MEMORANDUM

SUBJECT: Project Update #7; NAS Memphis RFI; Millington, Tennessee; CTO-094

DATE: January 17, 1995

FIGURE 2
PROPOSED MONITORING WELL LOCATIONS
BUILDING N-121
SWMU 3

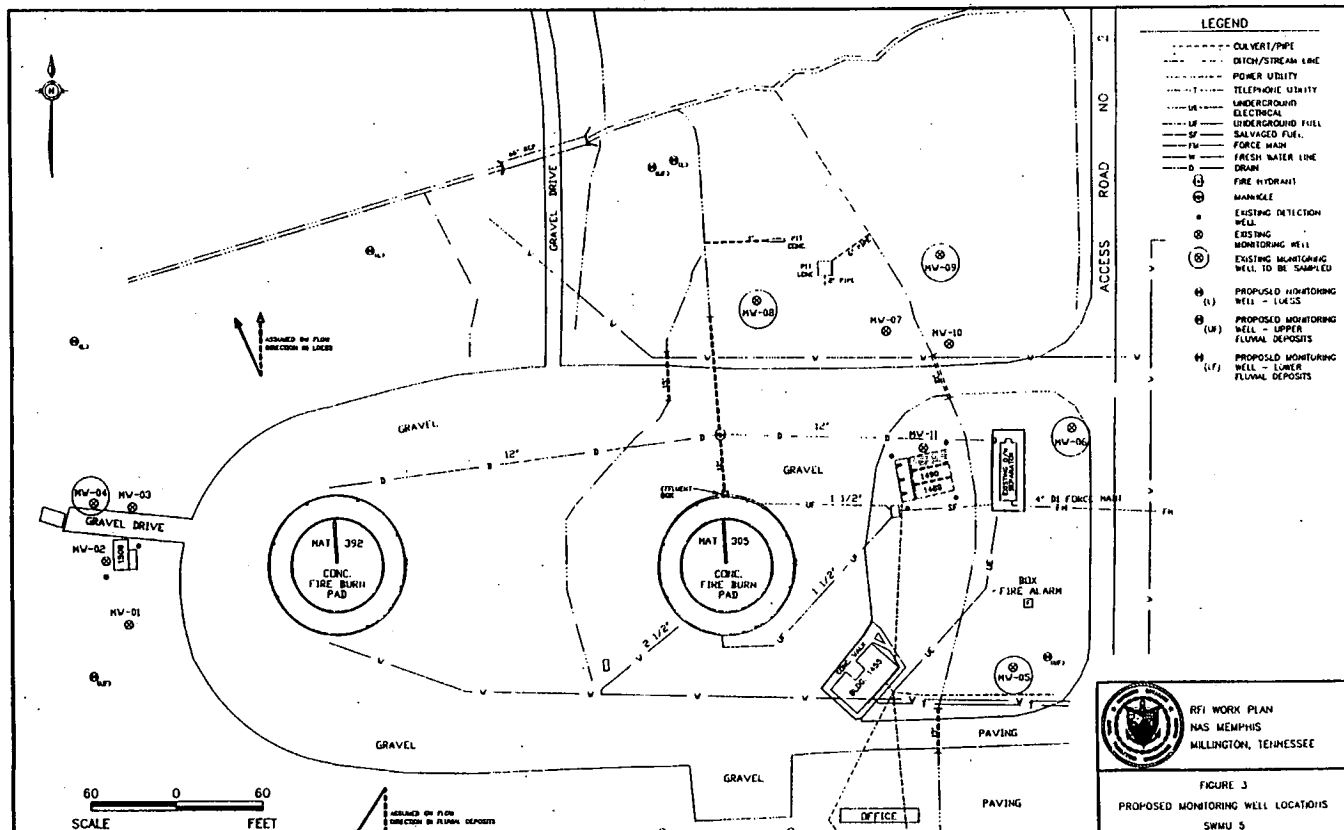
SWMU 3 (N-121 Plating Shop Drywell) — Add one monitoring well screened in the lower fluvial deposits at the drywell. PVC is okay for well construction; however, we should sample for solvents within 48 hours of well development, if possible.
